**From:** Andrae, Bill/MKE [William.Andrae@jacobs.com]  
**Sent:** 3/25/2020 9:08:55 PM  
**To:** Gsellman, Patrick [PGsellman@akronohio.gov]  
**CC:** Giancarlo, Mary Beth [Giancarlo.Marybeth@epa.gov]; Reif, Marty/WDC [Marty.Reif@jacobs.com]; Walter, Drew/MKE [Andrew.Walter@jacobs.com]  
**Subject:** Gorge Dam - Chuckery Area Utilities Questions

1) 15" Vitrified Clay Pipe (VCP)

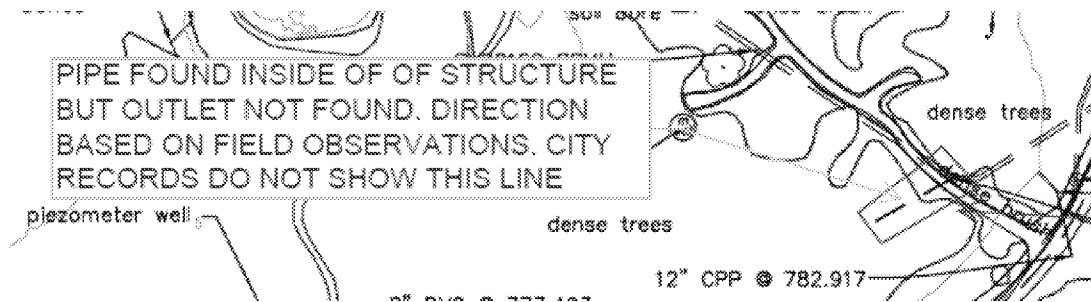
Need to confirm the status, active or abandoned

Mike, please provide the coordinates for the two shots below

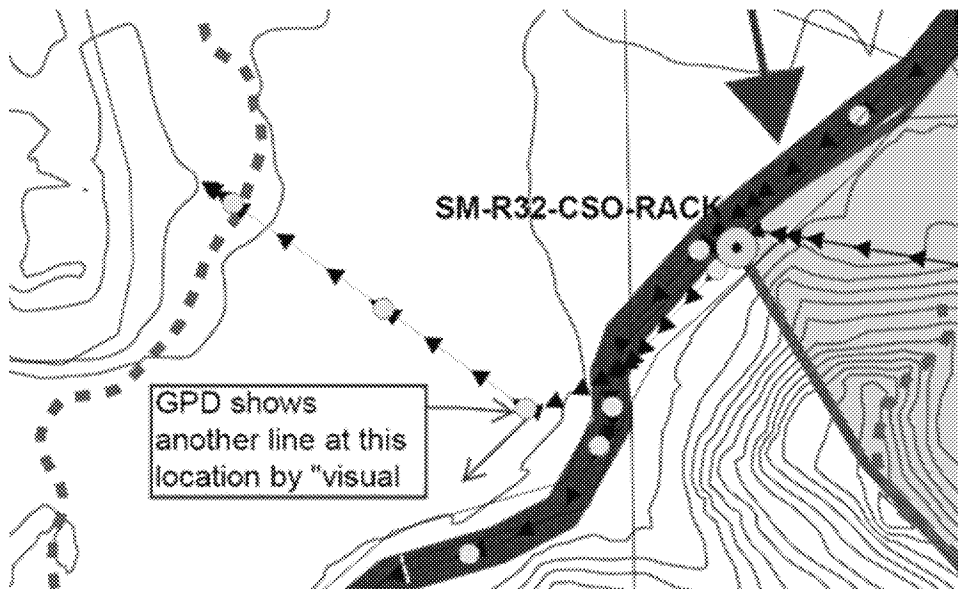
2) Need to verify the sewer lines at the following manhole (SV60394):
